APPROVED

Limited building only review
Permit holder responsible for
full compliance with the code

Stephenie Marshall Residence
36 Lansing Ct. East
Sanford N.C. 27332

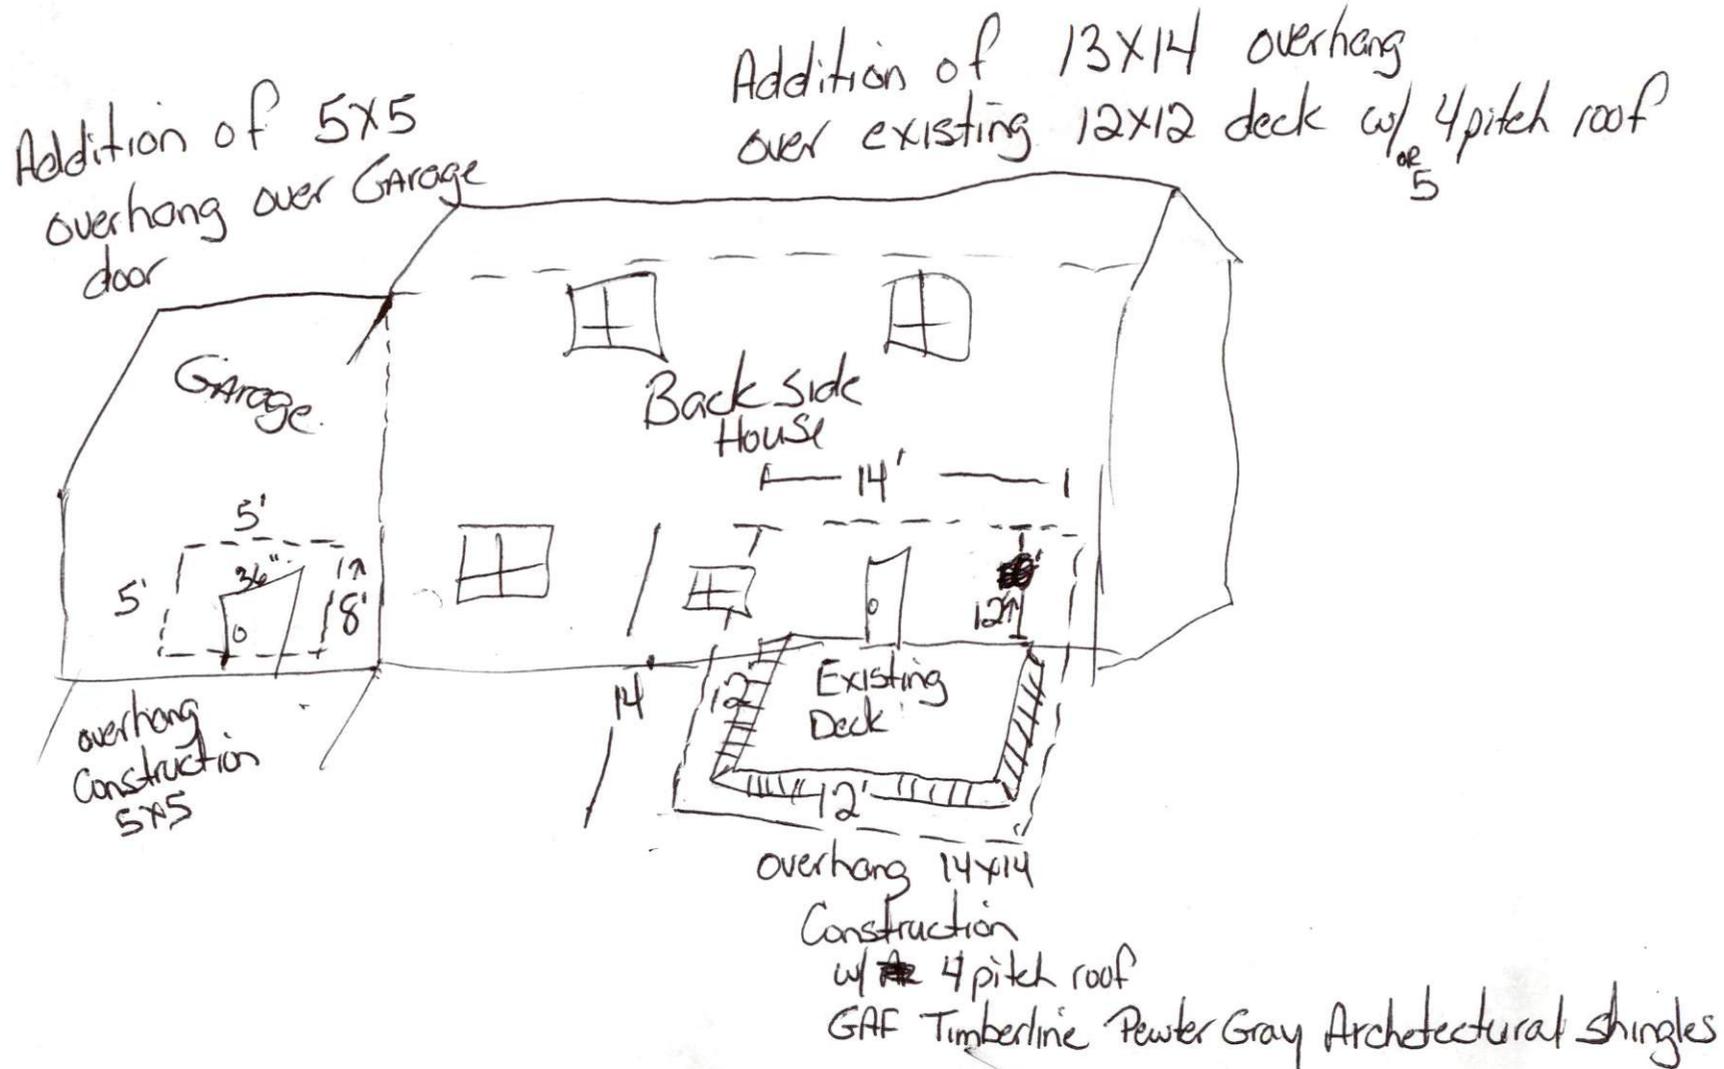
Posts must have code compliant footings
Bands supporting rafters must be double
Band to post shall be with 1/2 through
bolts/nuts/washers, or approved hangers.
